GRADING AND EROSION CONTROL PLAN

1185 N Curtis Rd, Colorado Springs, CO 80930

Grading and Erosion Control Plans (standalone)

GEC PLAN COVER SHEET

SHEET NUMBER:
D-2

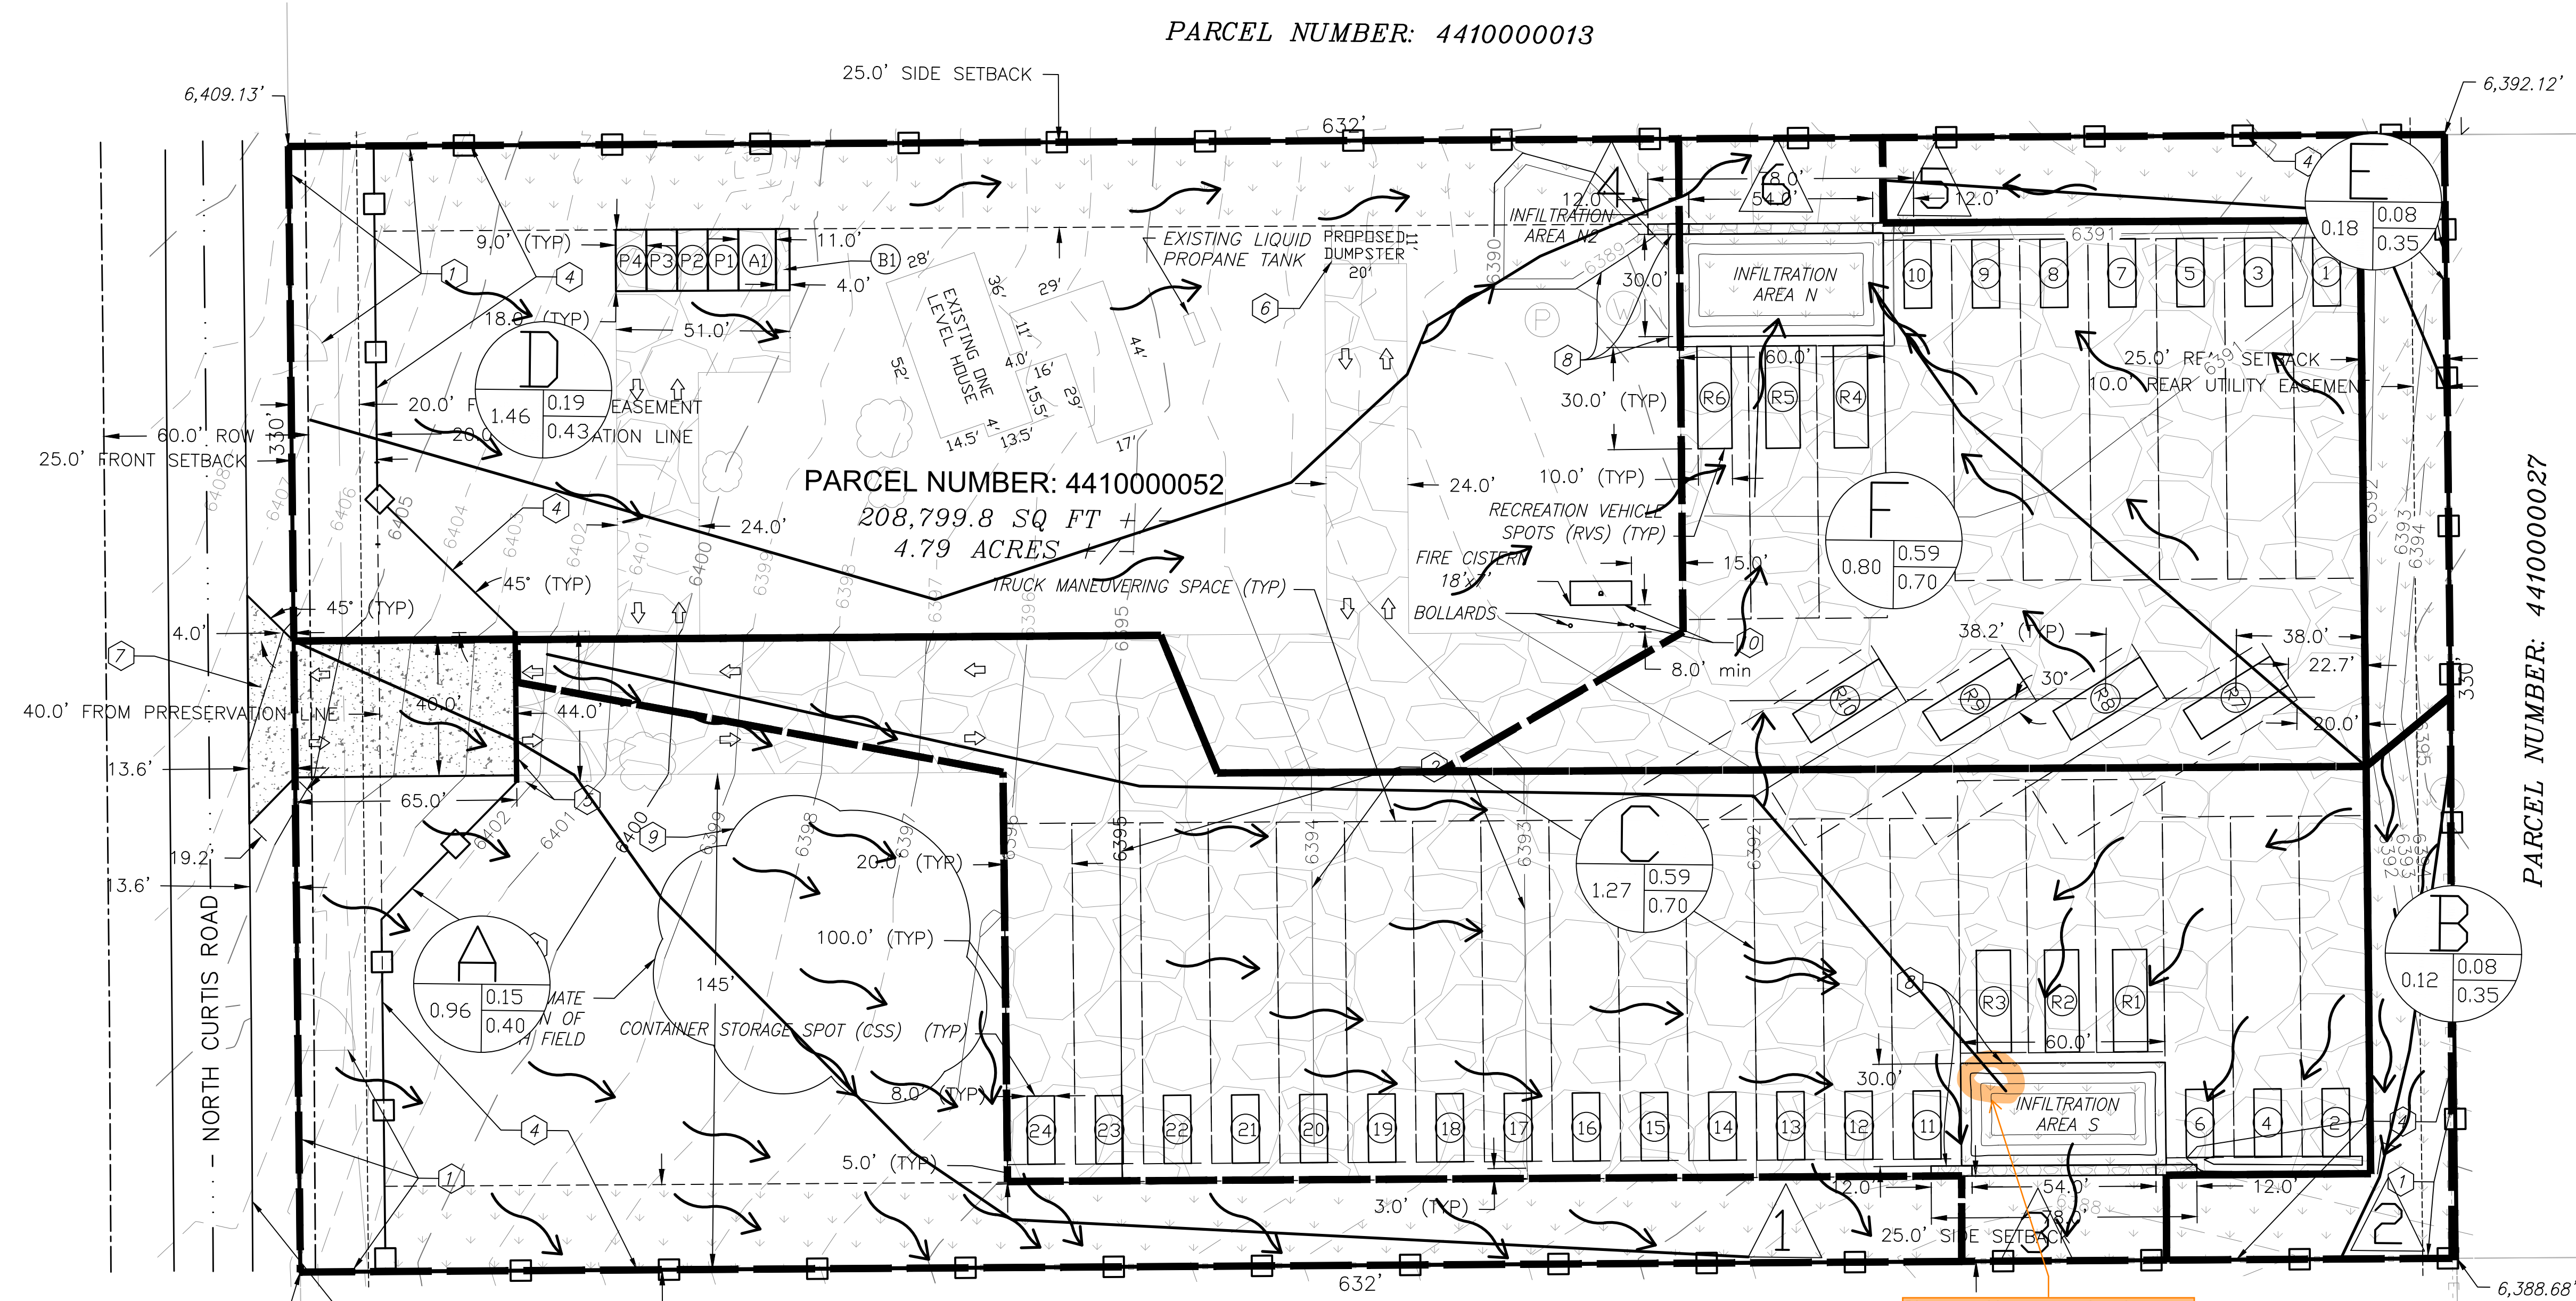
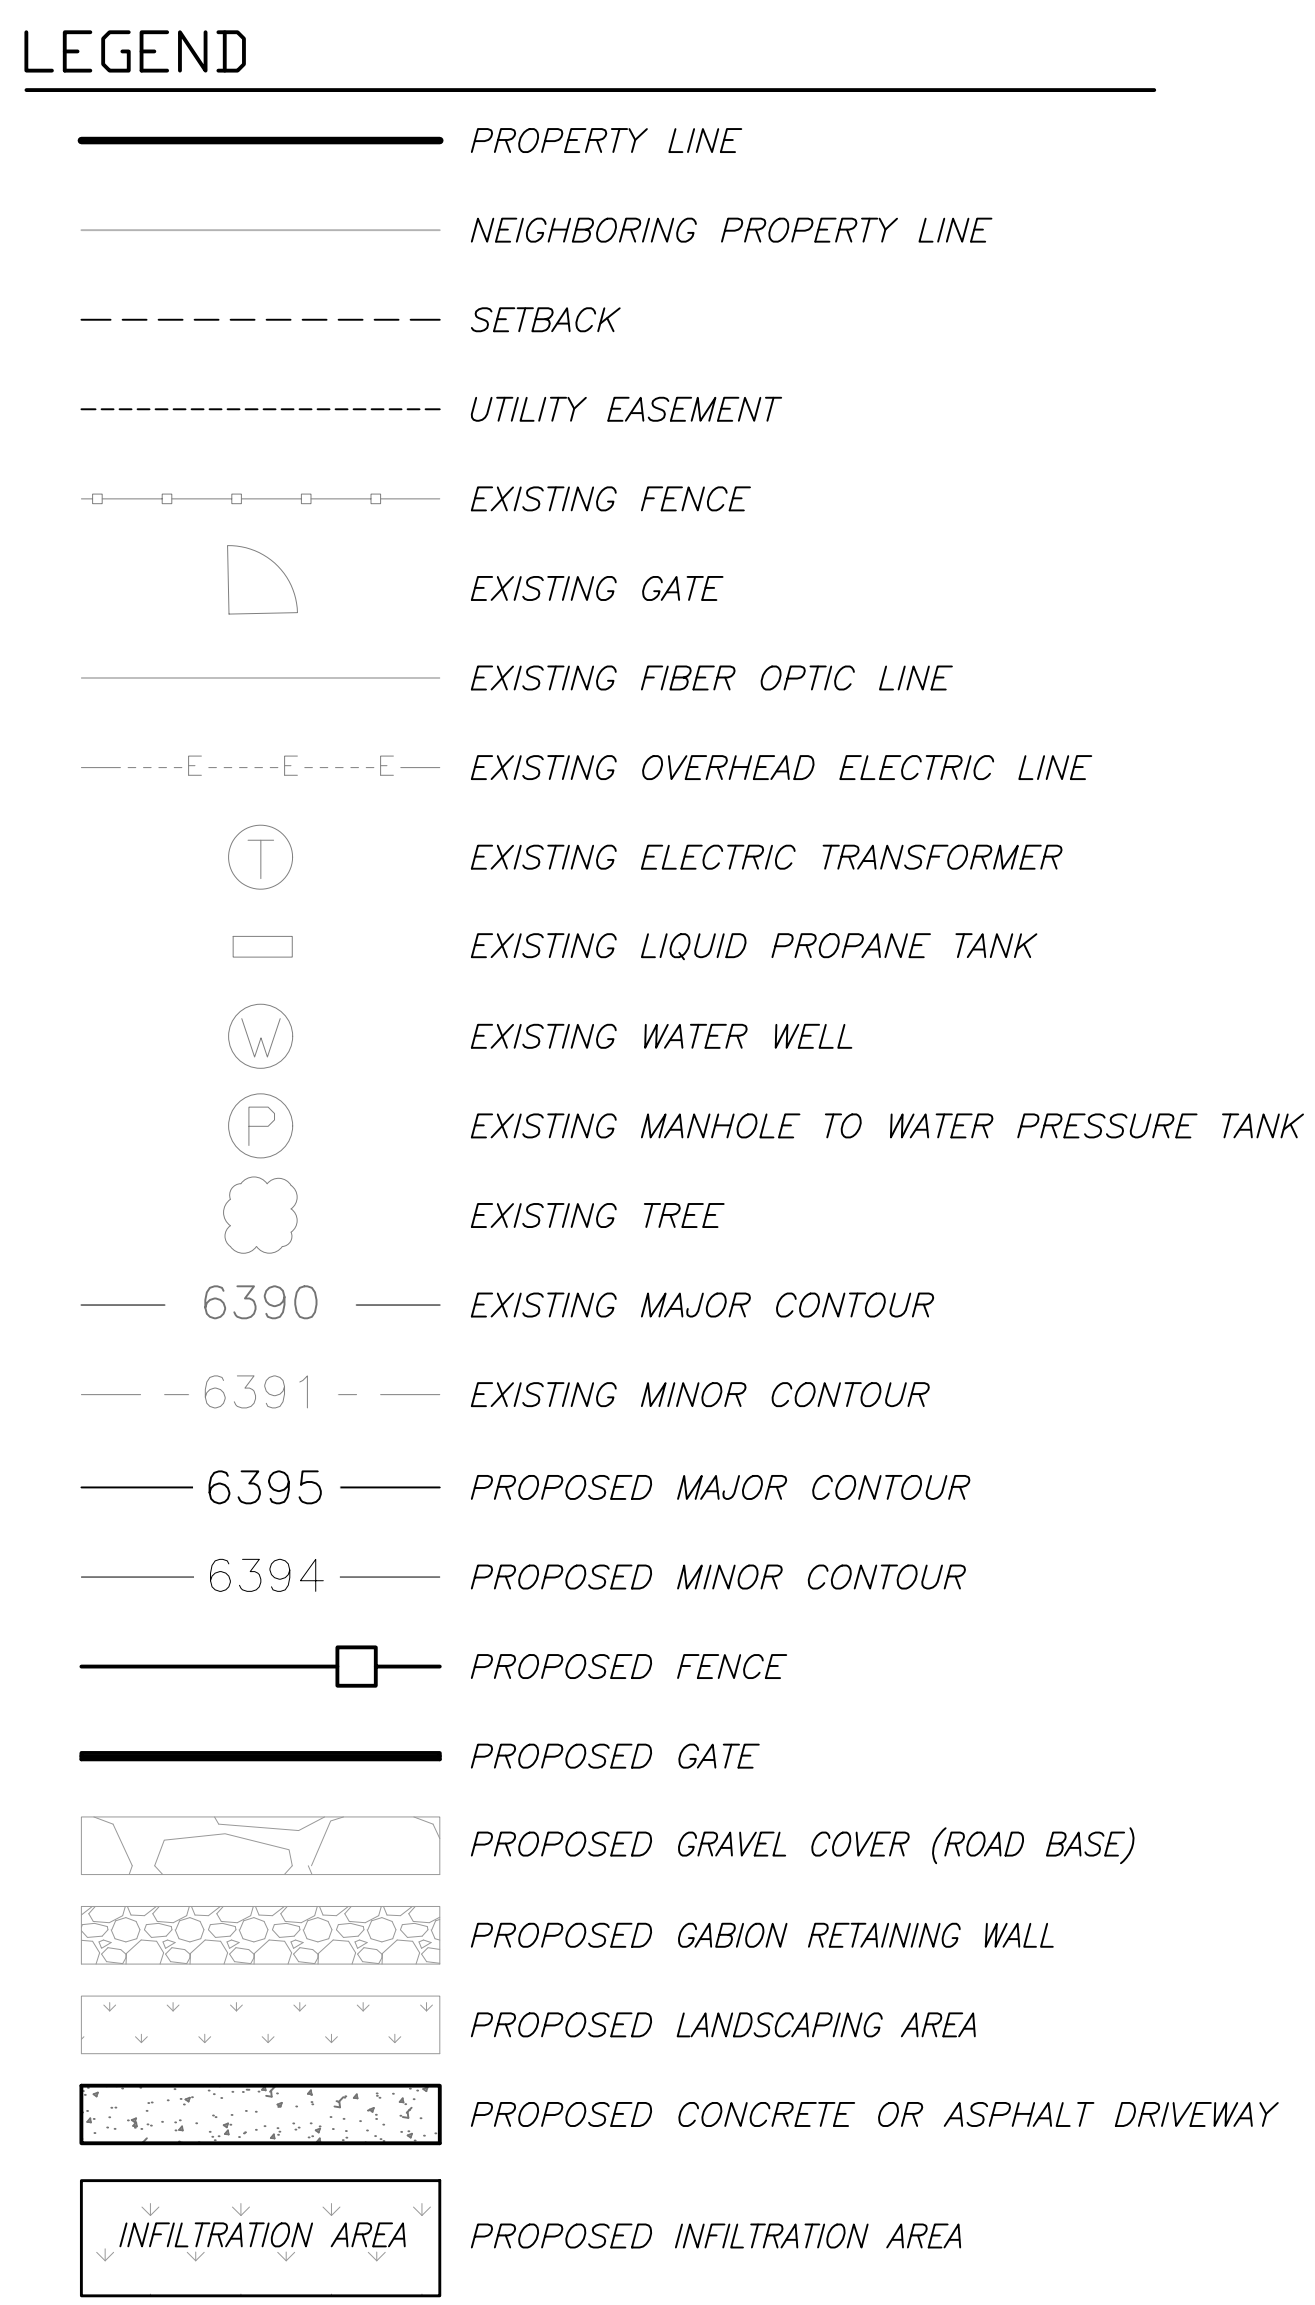
Please provide an armored rundown to the pond bottom for the area with the longest flow path. I recognize the majority of flows will sheet flow into the pond, but this area needs to be protected because the design shows concentrated flows will enter at this location. Concentrated flows will damage the embankment over time, and armoring is required to prevent constant maintenance.

POND N2 3D VIEW
SCALE: NTS

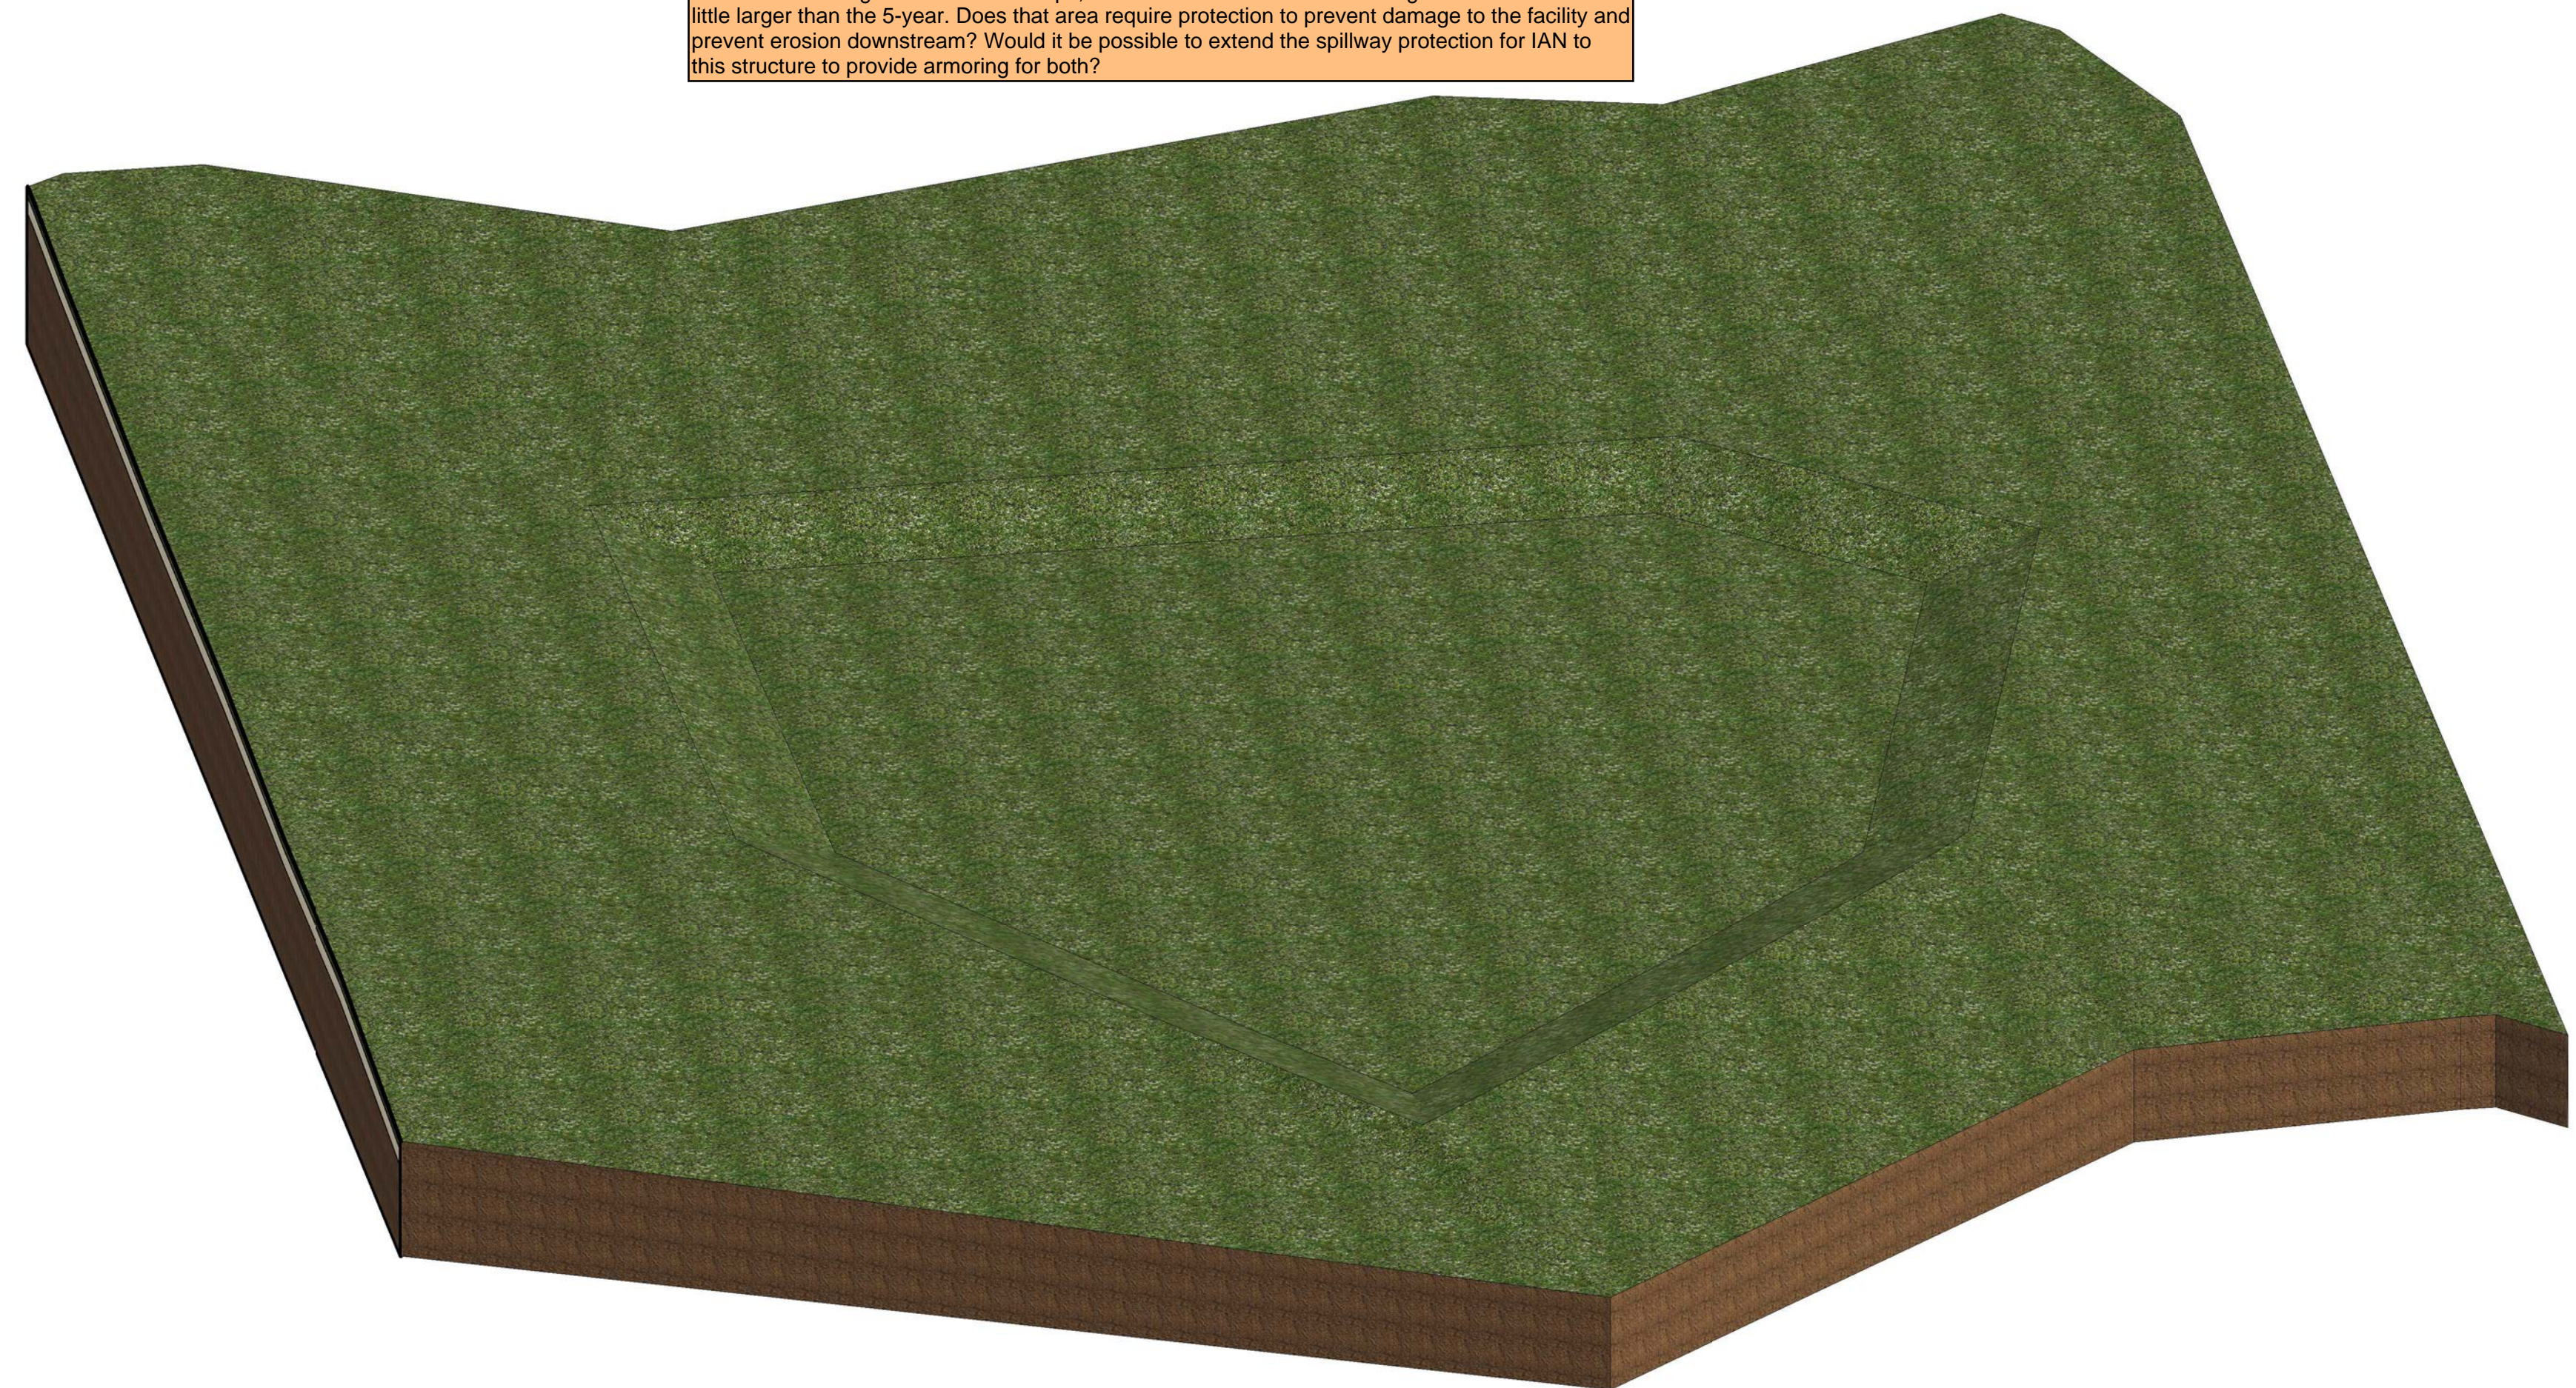
Where will runoff go when this over-tops, which calculations show it is designed to do on storms a little larger than the 5-year. Does that area require protection to prevent damage to the facility and prevent erosion downstream? Would it be possible to extend the spillway protection for IAN to this structure to provide armoring for both?
